Subject: Langley Forest, Section 4, Lot 6, 6630 Holland Street, Tax Map #021-2-02-0006,  
Grading Plan dated September 20, 2004, Dranesville District

Reference: Resource Protection Area Encroachment Exception Request #026928 (Reconsideration  
of #026714)

RESPONSE TO COMMENTS

PLANTING PLAN

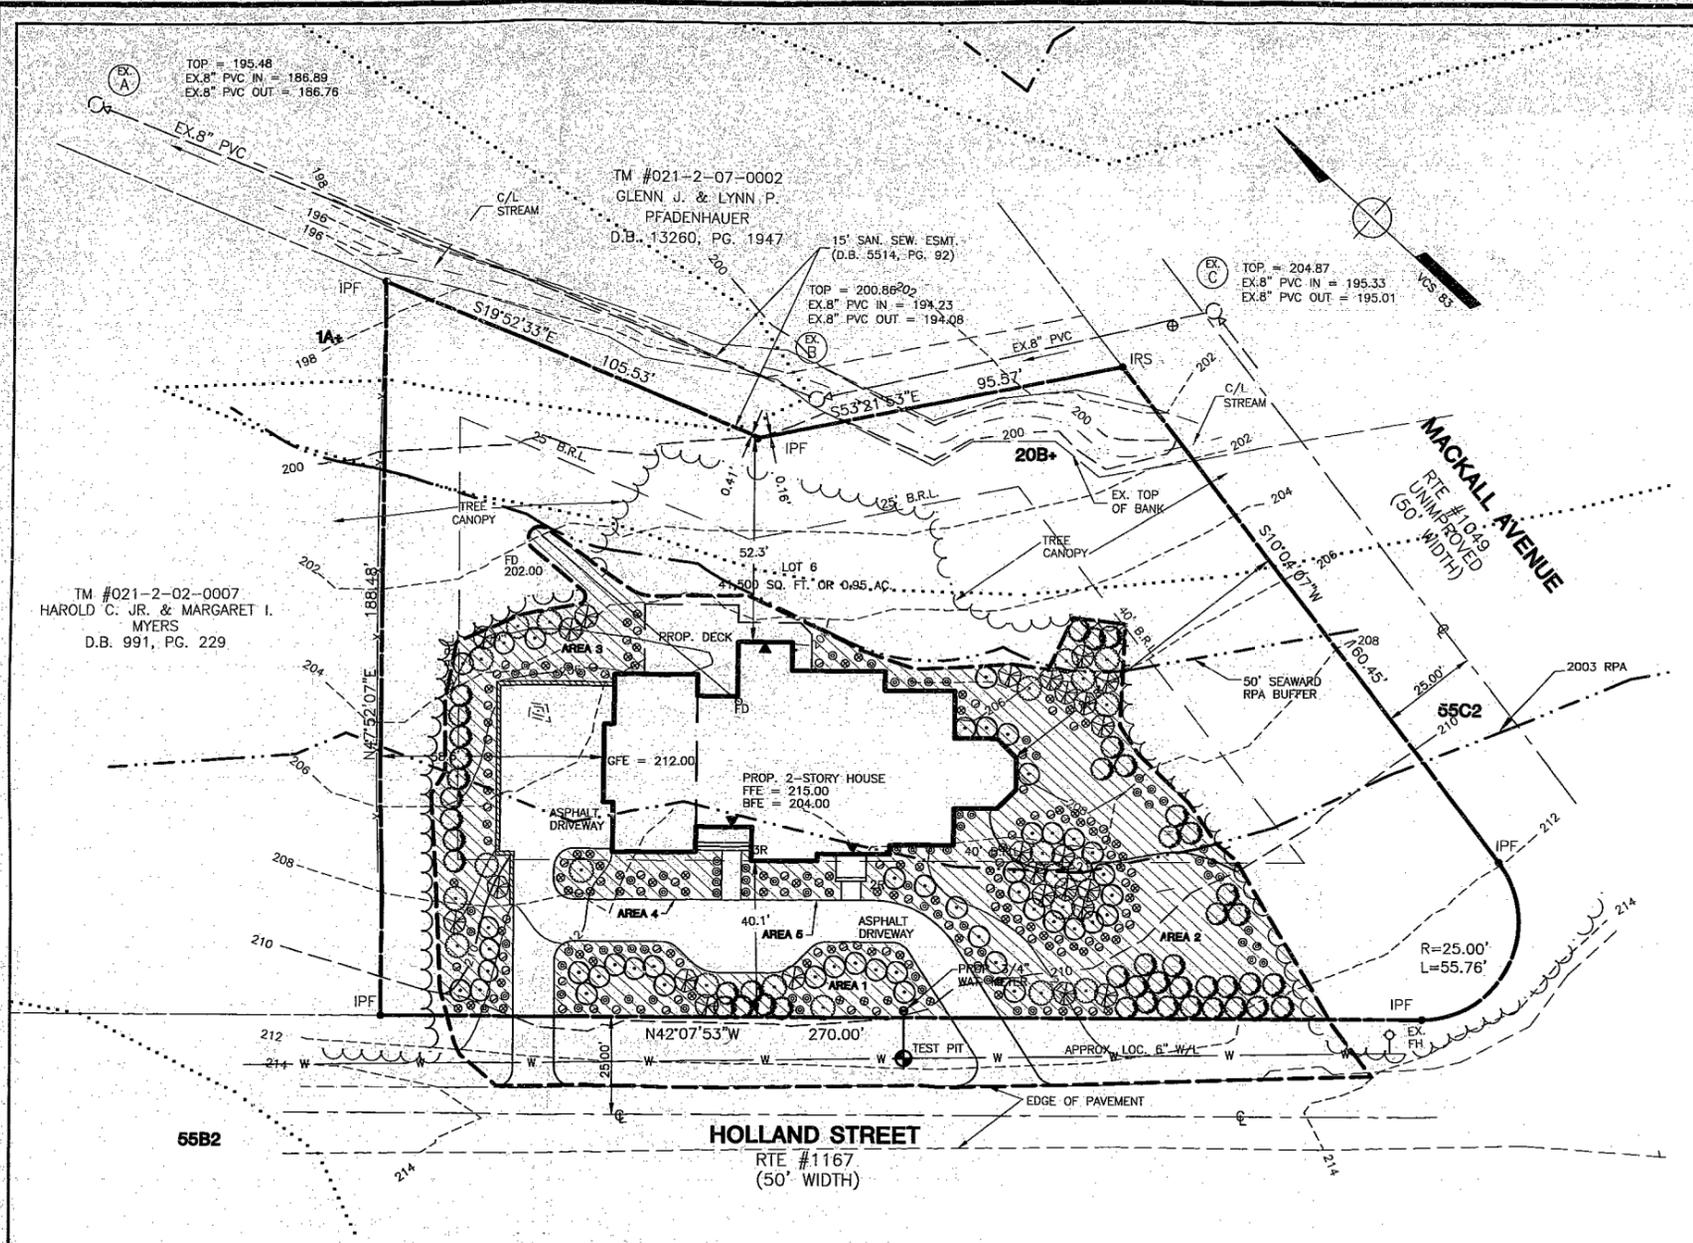
Comment 2: Delineate on the plan the area of encroachment, top of bank of the stream, and the vegetated buffer area that is equal to the area of encroachment. A planting plan, for the buffer in accordance with 118-3-3(f), is required.

*Show buffer of creek provide concrete curb along stream by sheet 4 (P 3 & 4) & approved sheet*  
Comment 2: Delineate on the plan the area of encroachment, top of bank of the stream, and the vegetated buffer area that is equal to the area of encroachment. A planting plan, for the buffer in accordance with 118-3-3(f), is required.

Response: The top of bank and area of encroachment have been shown on the plan. A planting plan (see sheet 4) delineating a vegetated buffer that is equal to the area of vegetation removed from the buffer area. The disturbed area calculations for the RPA are shown on She. 2.

**Response:** The top of bank and area of encroachment have been shown on the plan. A planting plan (see sheet 4) delineating a vegetated buffer that is equal to the area of vegetation removed from the buffer area.
